Interactive comment on "Development of fragility curves for railway ballast and embankment scour due to overtopping flood flow" *by* R. Tsubaki et al.

Anonymous Referee 1

Figure 3 Why the damage probability of the upper-limit of no-damage observation is not zero.

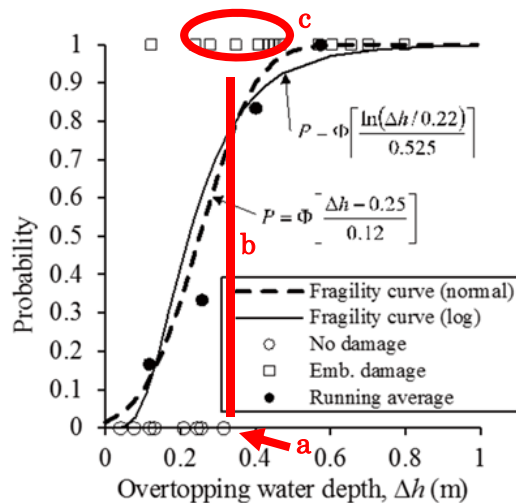
Comment 1-32: Line 338: I am confused. The upper limit (double line) indicates already a probability of damage of about 0.8-0.9 while the authors mentioned

that no-damage was observed. Please, clarify this sentence providing additional information;

Reply: The upper limit indicates the largest overtopping water depth with no-damage record in the field. We guess the reviewer is confusing why the damage probability of the hazard level that no-damage was observed is not zero, because of the no-damage was observed. Not only no-damage record (data point a in Figure 3 below) but damage record existed (data points c in Figure 3) in the range that no-damage was record so the damage probability did not 0 nor 1. We will add the description about this point.
